UNITED STATES
NUCLEAR REGULATORY COMMISSION
WASHINGTON, D.C. 20555-0001

SAFETY EVALUATION BY THE OFFICE OF NUCLEAR REACTOR REGULATION

SUPPORTING AMENDMENT NO. 31 TO

THE MASSACHUSETTS INSTITUTE OF TECHNOLOGY

Figure 3 Top View of the Fission Converter Facility

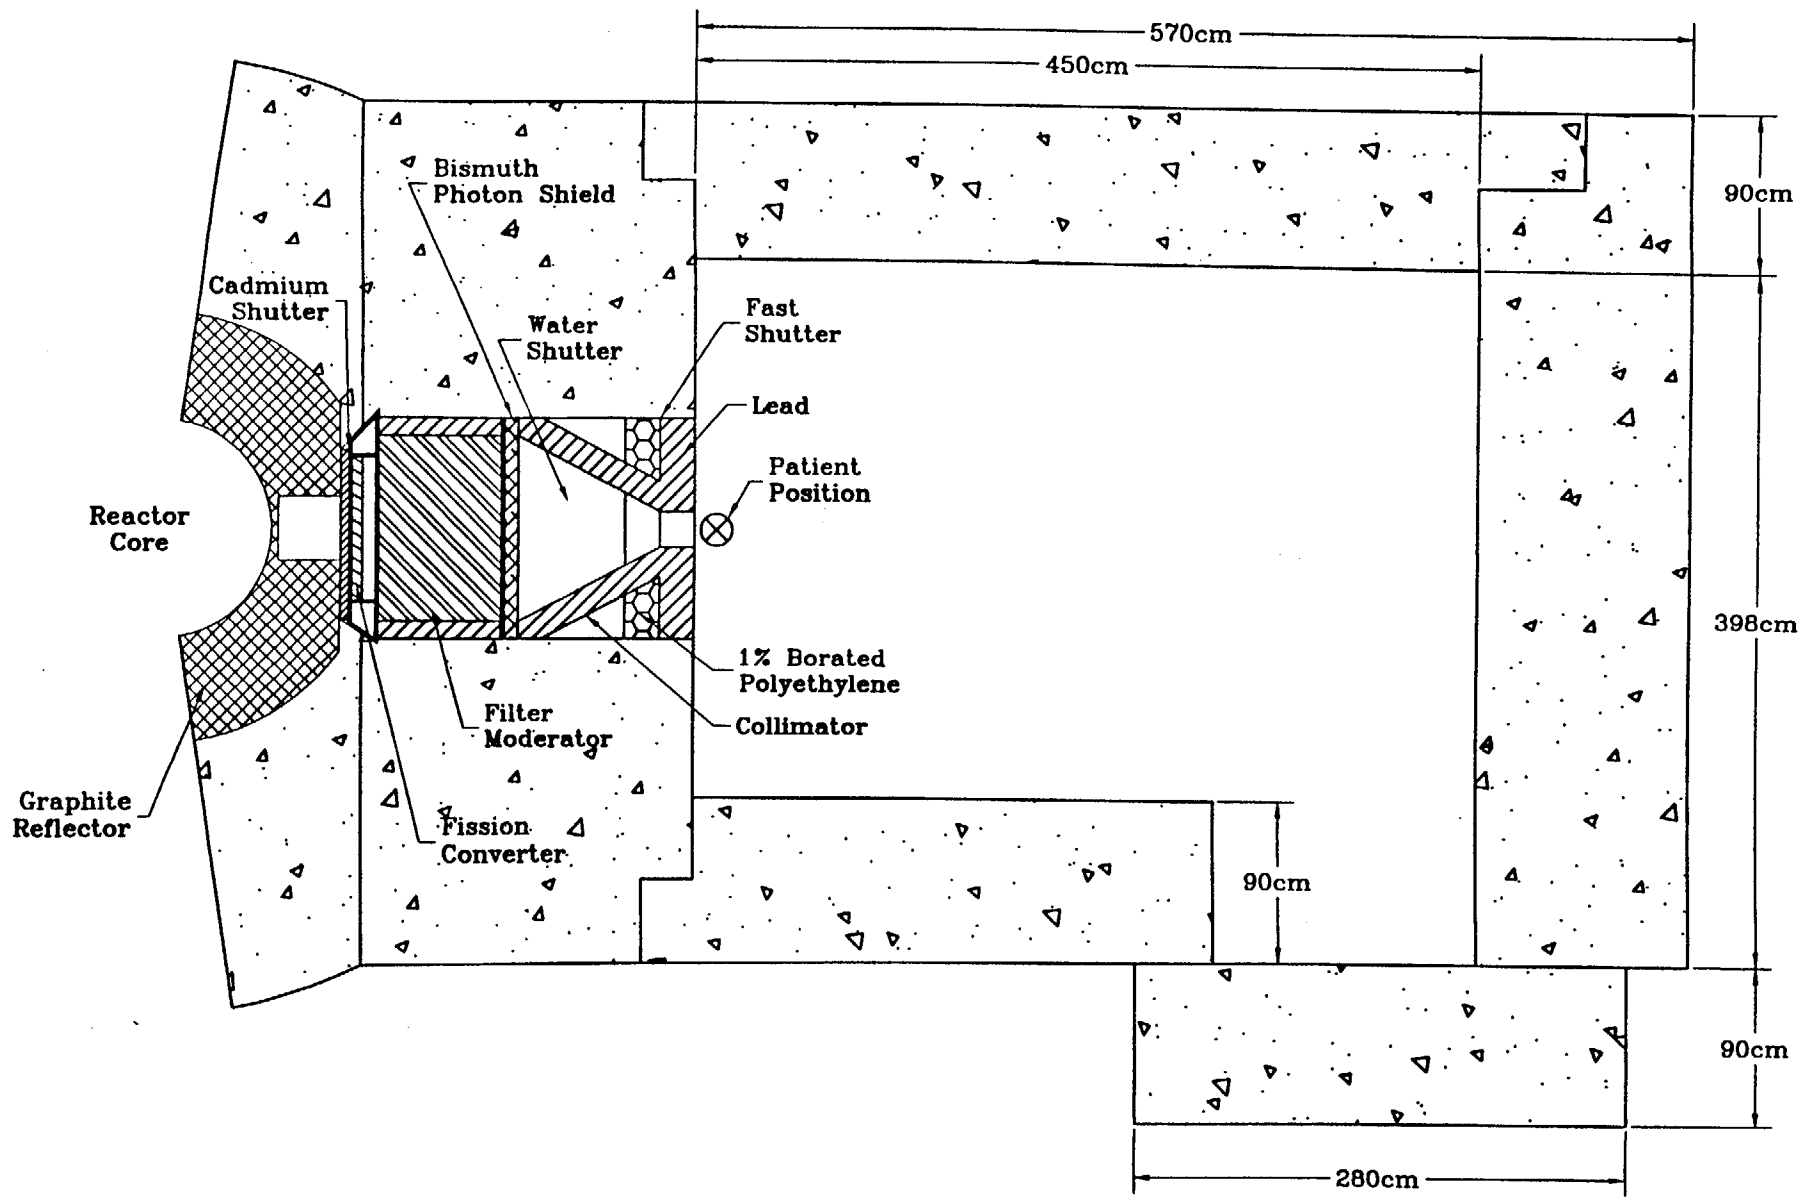
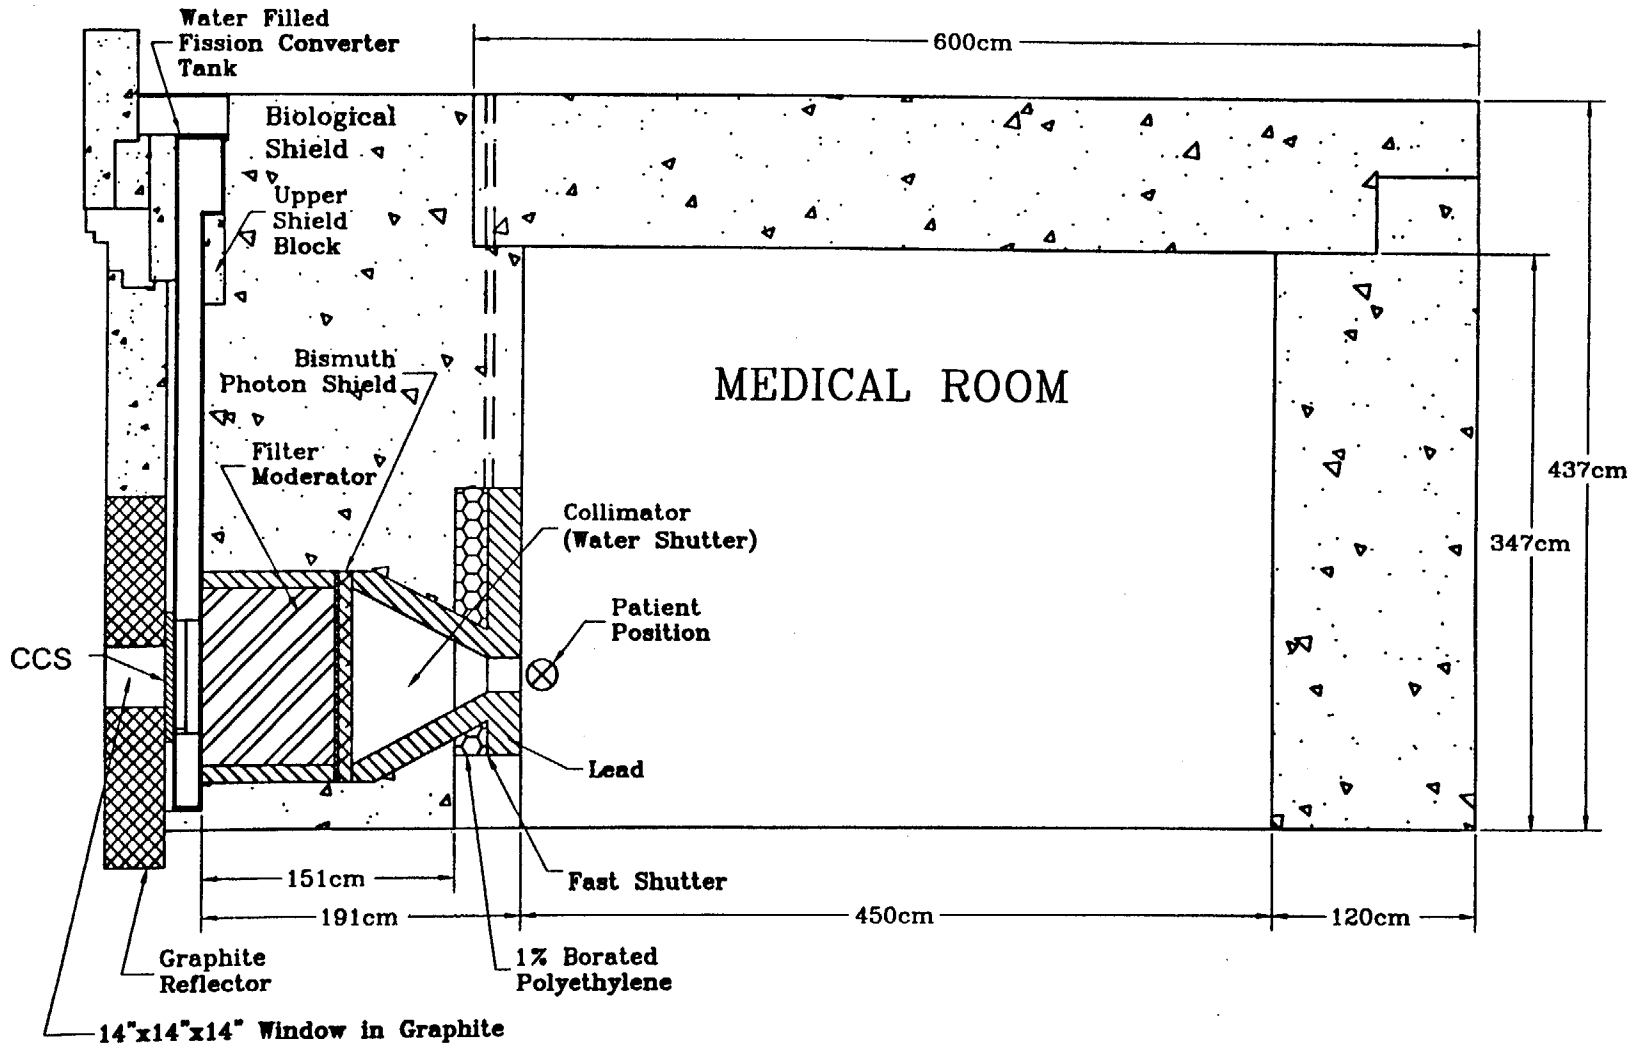
The location and the arrangement of the shutters are shown in Figures 3 and 4.

Figure 5 Isometric View of Fission Converter Tank Design

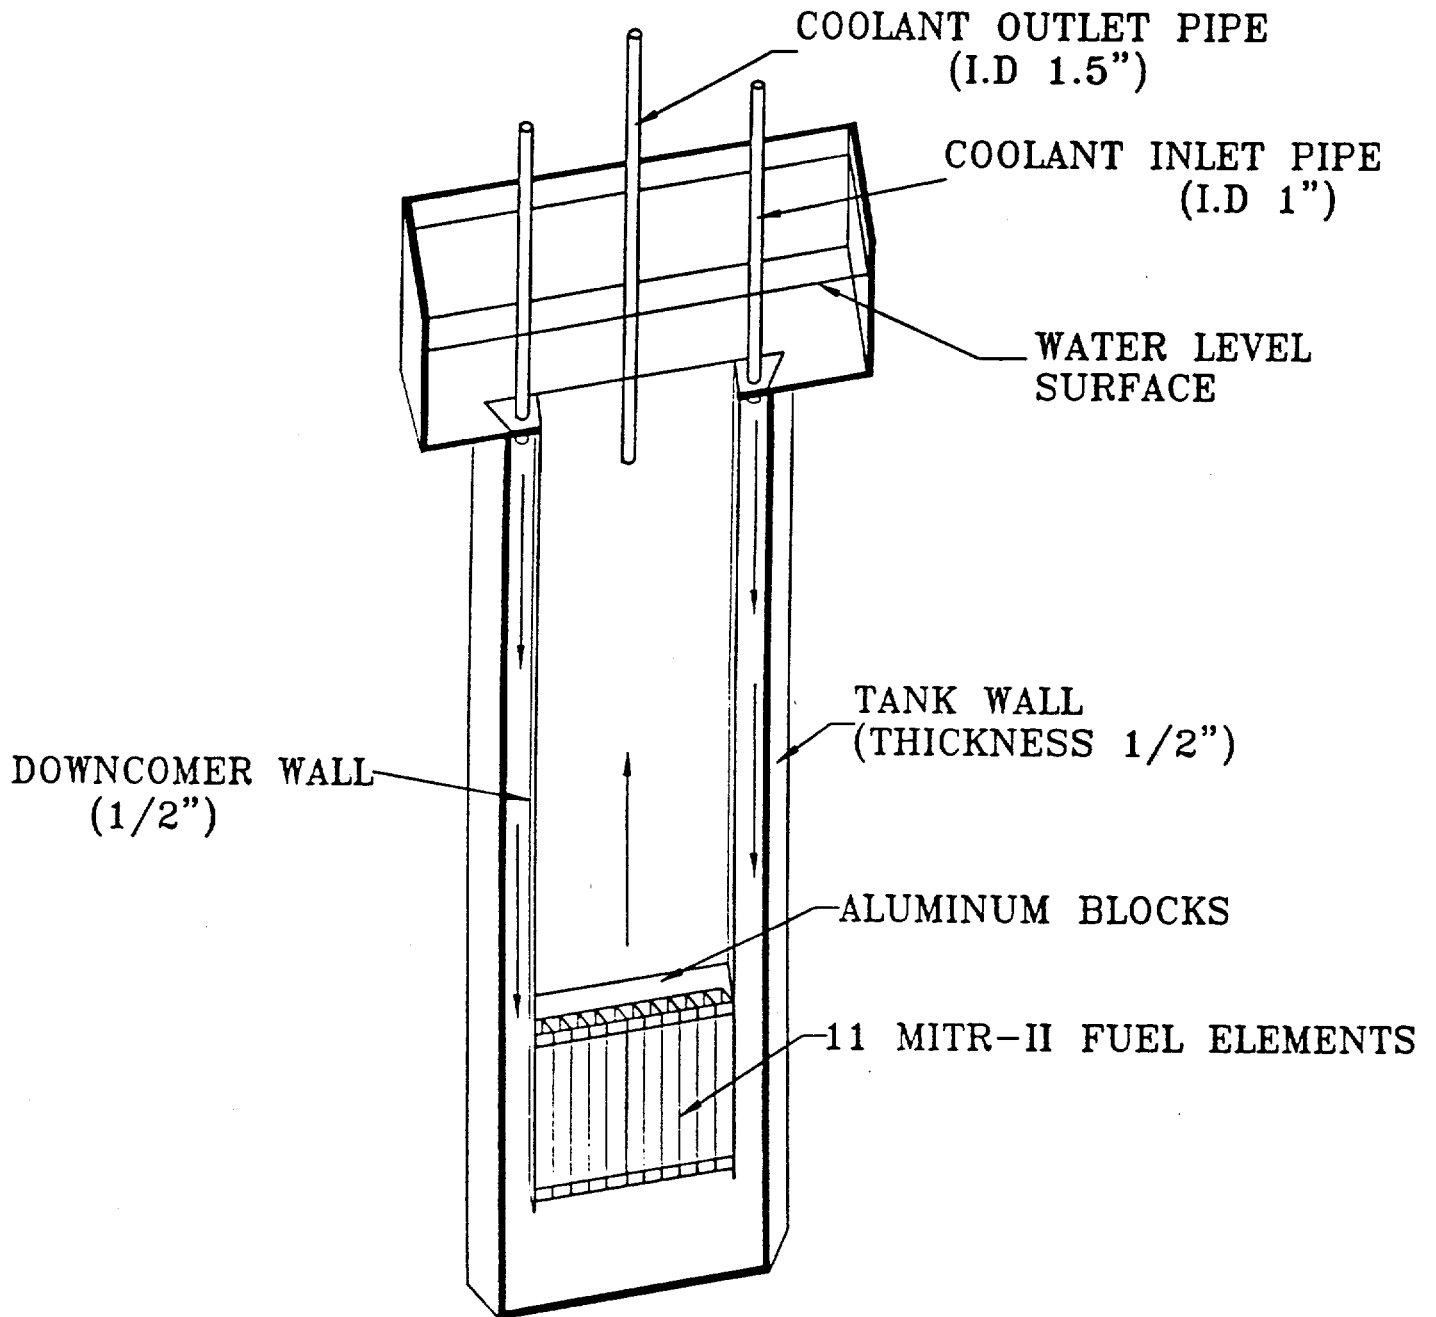
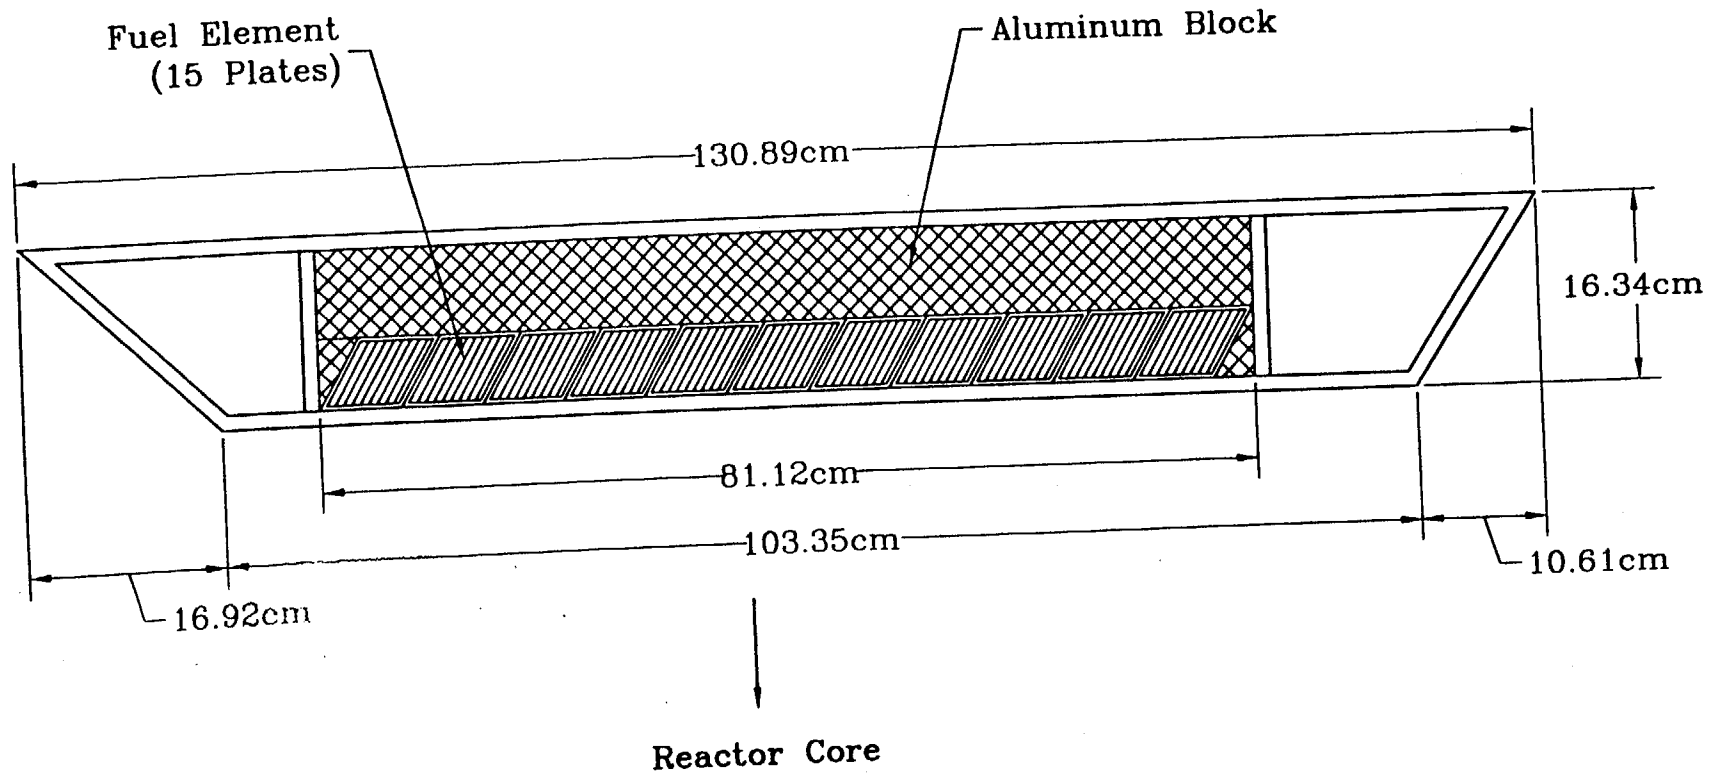
Figures 5 and 6 present an isometric and cross-sectional view, respectively, of the fission converter tank and the fuel location. It is possible to insert an aluminum block (that displaces the coolant/moderator near the fuel in order to improve the epithermal neutron beam) between the fuel and the converter tank wall. Proposed TS 6.6.4-5 requires the aluminum block to be installed unless calculations have been performed to show compliance with certain important design criteria with the block removed. Unless otherwise stated, the NRC staff's analyses and conclusions assume that the aluminum block is in place.

Figure 7 Schematic Drawing of Fission Converter Heat Removal System

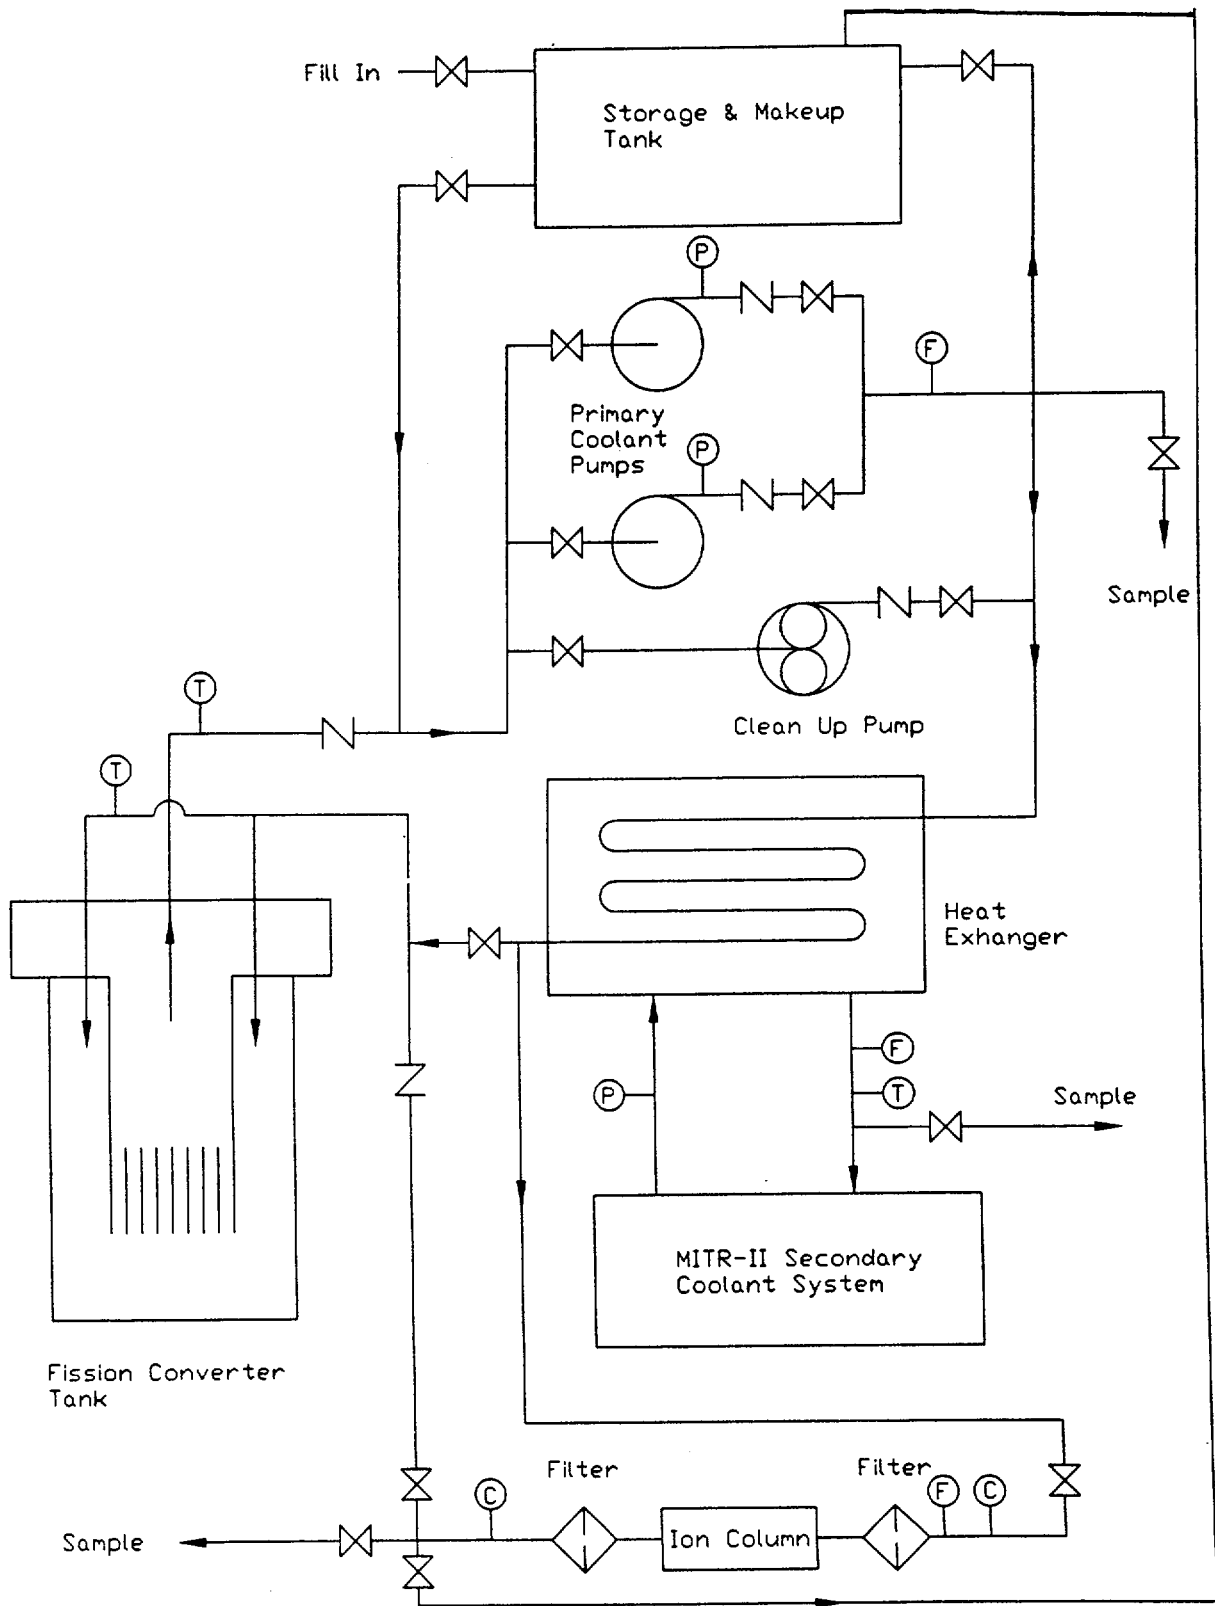
Figure 7 is a schematic drawing of the heat removal system of the fission converter. Also shown on this drawing are the ion exchange water clean up system and the makeup water system. Proposed TS 6.6.4-6 concerning design features of the cooling system requires that pumps and other components of the fission converter's primary cooling system be located to prevent uncovering of the fission converter fuel elements as a result of siphoning. Because it will help to ensure that the fuel elements remain covered with coolant, this TS is acceptable to the staff. The staff finds that the design of the cooling system meets this requirement.

Figure 8 Schematic Drawing of Fission Converter Cover Gas System

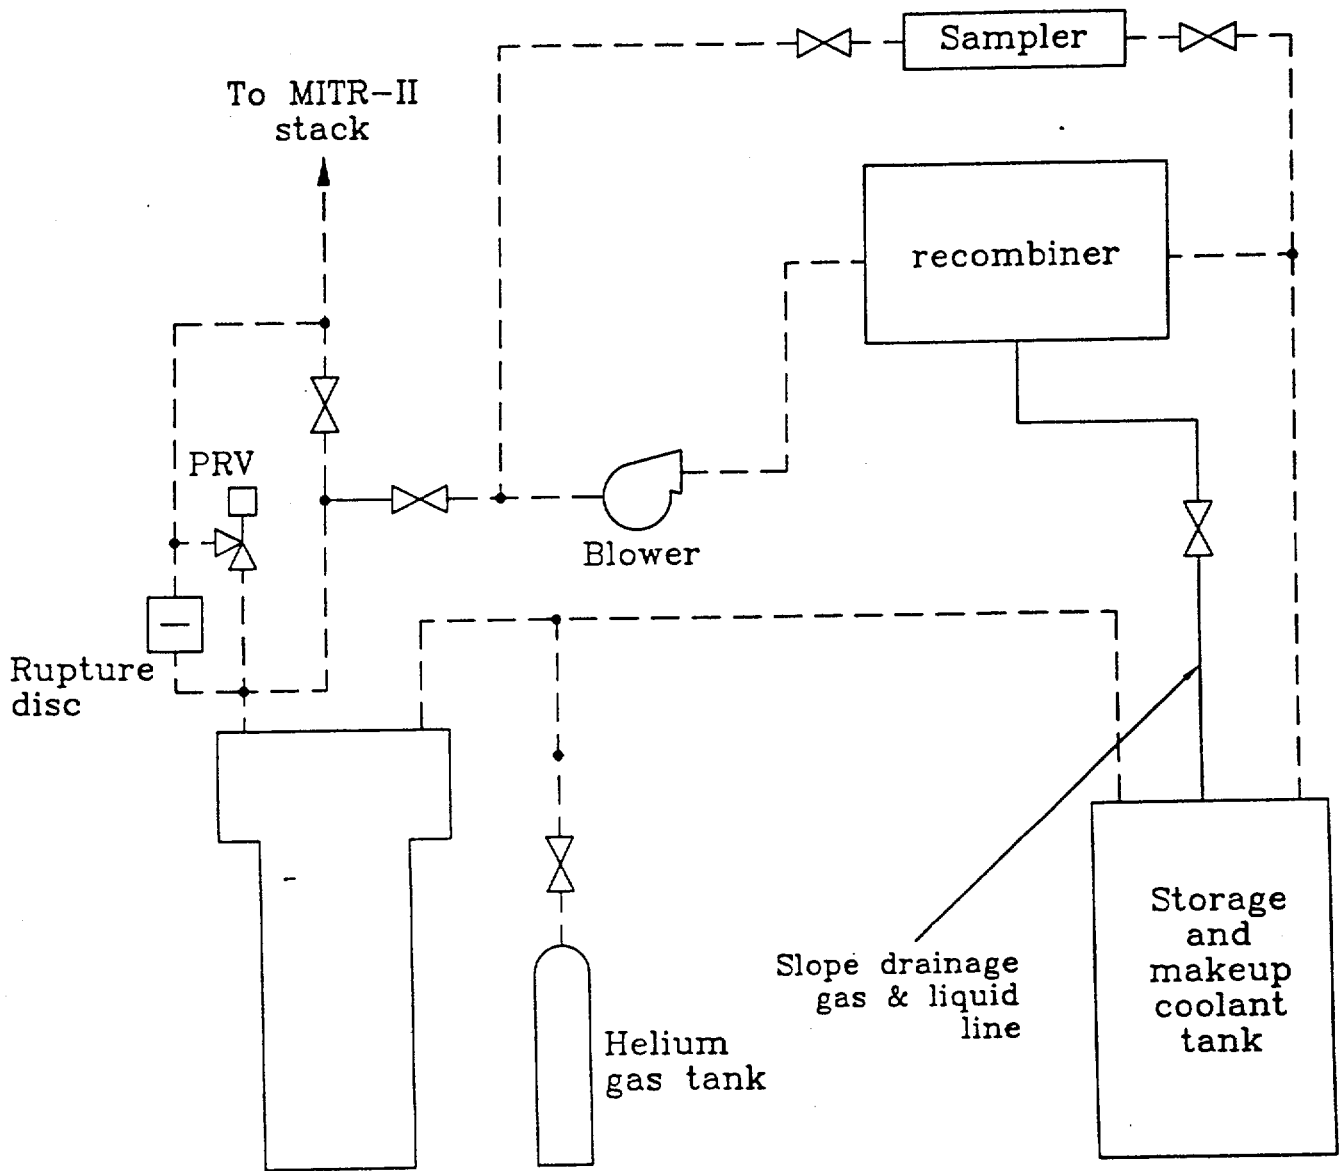
Figure 8 presents a schematic drawing of the helium cover gas system for the fission converter. The cover gas system has several important functions. These include maintaining the quality of the D₂O (if used), inhibiting the production of nitrous oxide, minimizing Argon-41 production, and providing a means to monitor for fission gases that would indicate a fuel element clad failure. An additional function is to provide an inert atmosphere for the circulation of radiolytic decomposition products through a recombiner. The conditions of operation of this recombiner are specified in proposed TS 6.6.2.4. This TS limits D₂ and H₂ concentration in the helium blanket to not exceed six volume percent, requires the recombiner to be operated for a minimum of five hours per month in any month that the converter was operated, and contains a requirement that if the recombiner is not operable, fission converter operation may continue as long as samples of the helium blanket are taken weekly and the D₂ or H₂ concentration in the helium blanket does not exceed two volume percent. The licensee has based operation and operating limits of the cover gas system on the similar system for the MITR which has been in use for many years without incident. The cover gas system is protected against over pressure with a relief valve and a rupture disk. The nominal relief setting of the valve and the nominal rupture pressure of the disk will be 4 psig and 5 psig respectively. The licensee states that the fission converter tank will be tested to 10 psig.

The staff reviewed the description of the cover gas system that the licensee is proposing. The design is based on the considerable incident free experience with a similar system used with the MITR. The pressure testing of the system and the use of the proposed over pressure protection is additional conservatism in the design. For these reasons the design as proposed by the licensee is acceptable to the staff.
